United States Patent and Trademark Office

APPLICATION N	NO. I	FILING DATE	FIRST NAMED INVENTOR	ATTORNEY DOCKET NO.	CONFIRMATION NO.	
10/775,353		02/10/2004	Phillip Frederick	10557/293163	10557/293163 1160	
30559	7590	03/10/2006		EXAMINER		
	PATENT C		SWIGER III, JAMES L			
	& NEPHEW, OOKS ROA	•		ART UNIT PAPER NUMBER		
MEMPH	IS, TN 381	116	3733			
				DATE MAIL ED. 02/10/2004	DATE MAILED: 02/10/2006

DETAILED ACTION

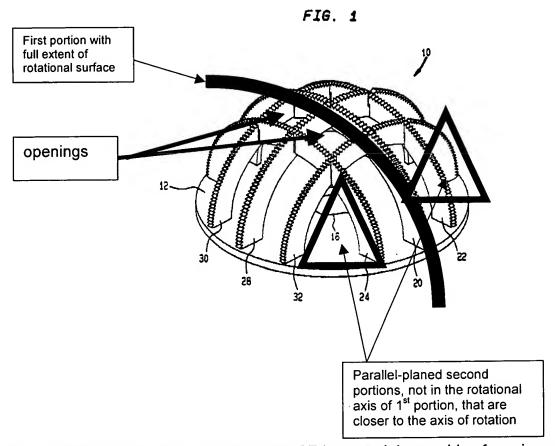
Claims 1-5, and 8 are rejected under 35 U.S.C. 102(b) as being anticipated by Frieze et al. (US 5,775,719). Frieze et al. disclose a reamer having a hollow body having a general dome shape (10) forming an inner and outer surface, and is capable of rotating on an axis (16). The device also has a plurality of raised edges for cutting bone (42) or cartilage, and a plurality of openings for the passing the fragments into the interior portion of the reamer (see drawing below). Also shown below is the reamer disclosed by Frieze et al. having a first portion dimensioned as a surface of rotation, and a second portion not forming a surface of rotation that is generally located closer to the axis of rotation that the first portion. For clarification, the triangular sections represent a portion of the reamer head that may be considered a second portion, separate from the shown first "banded" and rotational portion. These two portions are closer to the location of the axis of rotation (16), than from the extents of the first portion as a rotational surface. Though difficult to show, the two triangles are in planes substantially parallel.
